<b>B 1</b>	SEQUENCE NO. (MDE USE ONLY)	<b>STATE OF MARYLAND</b> <b>APPLICATION FOR PERMIT TO DRILL WELL</b> please type	STATE PERMIT NUMBER <b>H0-25-0031</b> <small>fill in this form completely</small>
<b>OWNER INFORMATION</b> Date Received (APA) <u>11/11/25</u> 8 MM DD YY 13 Last Name <u>Glowacki</u> Owner <u>Andrew + Clarice</u> First Name <u>Clarice</u> 15 Street or RFD <u>5875 Carrollton Ave</u> 36 Town <u>Savage</u> State <u>MD</u> Zip <u>20763</u> 57 70 72 76		<b>LOCATION OF WELL</b> COUNTY <u>Howard</u> 21 SUBDIVISION <u>White Subd. 25B</u> 42 SECTION <u>44</u> 46 LOT <u>60</u> 50 NEAREST TOWN <u>Savage</u> 71	
<b>DRILLER INFORMATION</b> Driller's Name <u>David Kelly</u> License No. <u>MWD304</u> 76 81 Firm Name <u>JONES Well Drilling / Carroll WATER</u> Address <u>5100 South rd JARRICKSVILLE, MD 21091</u> Signature <u>David Kelly</u> Date <u>11/12/25</u>		<b>SOURCES OF DRILLING WATER</b> 1. <u>5875 Carrollton Ave</u> 11 STREET ADDRESS 30 2. <u>private source</u> 3. <u>side well at JARRICKSVILLE, MD 21091</u> ON WHICH SIDE OF ROAD (CIRCLE APPROPRIATE BOX) NORTH <input type="checkbox"/> WEST <input checked="" type="checkbox"/> EAST <input type="checkbox"/> SOUTH <input type="

FIGURE 4.5: Parallel Vertical Ground Heat Exchanger

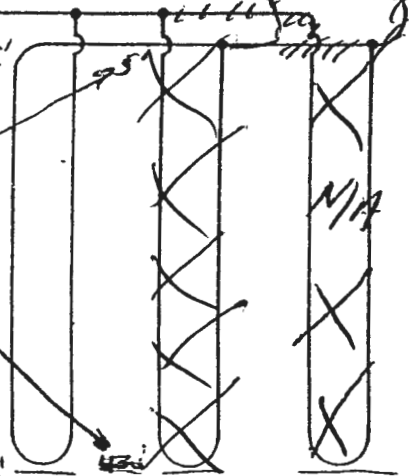
total depth ~~400~~  
 320'

Bore Lengths: ~~400~~ 320' x 2 holes (320' vertical bore)

Pipe Lengths: ~~400~~ 320' x 2 (320' vertical pipe)

LOCATION DIAGRAM

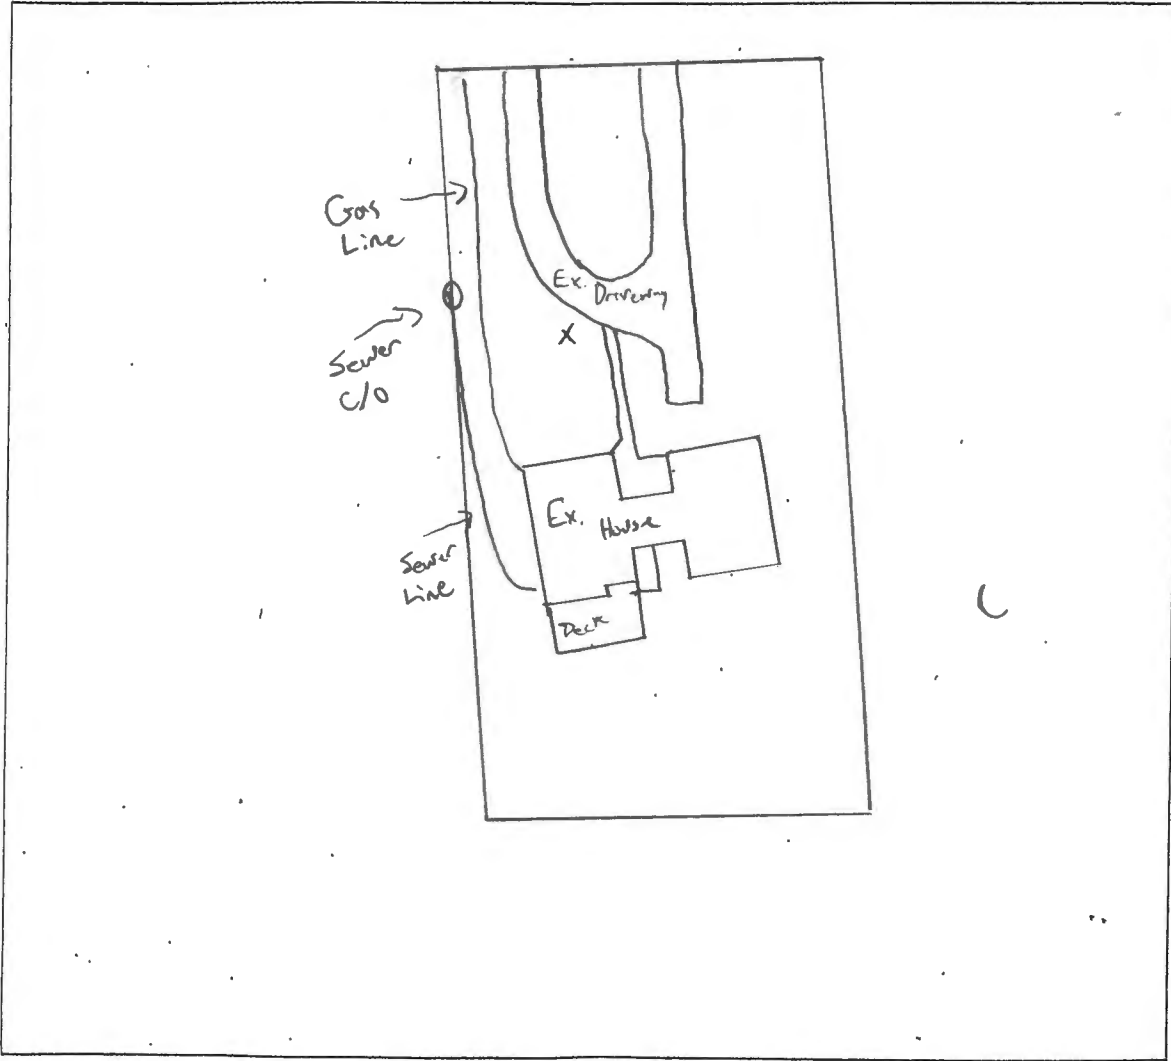
OWNER: Andrew + Clarice Glowacki PHONE #: \_\_\_\_\_  
ADDRESS: 8875 Carroll Ave CONTRACTOR: Carroll Water  
Savage, MD 20763 WELL TAG #: Public Water; N/A  
SUBDIVISION: White Subdivision RSB LOT: 60 COUNTY #: Howard  
PROPOSAL: Gas well location - does it meet 10' setback away from sewer line?

8/6/25  
COMMENTS: Met with Dave Kelly on site. Confirmed water, gas, and sewer line locations. Gas Well location is >10' away from sewer line. Gas Well location meets setbacks. Issued permit and well tag while on site. (MB)
